# Charlotte Department of Transportation

## Memorandum

**Subject:** Rezoning Petition 15-052: Approximately 36.10 acres located on the west side of Providence Road between Cloister Drive and Knob Oak Lane and across from Strawberry Hill Drive.

Figure 1

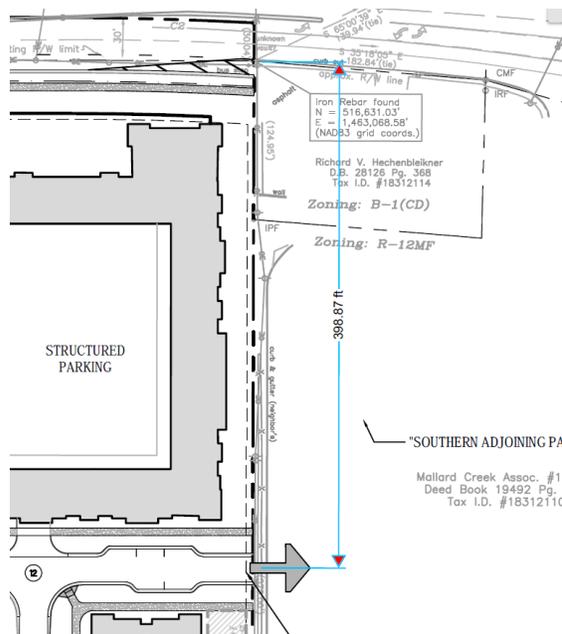
1. It appears that the proposed future street connection for the adjoining site to the south has not been fully coordinated with that of rezoning petition 2015-046. CDOT requests the petitioner coordinate efforts with the adjoining property owner to reflect a consistent street connection between the two properties. See Figures 1 and 2 below.
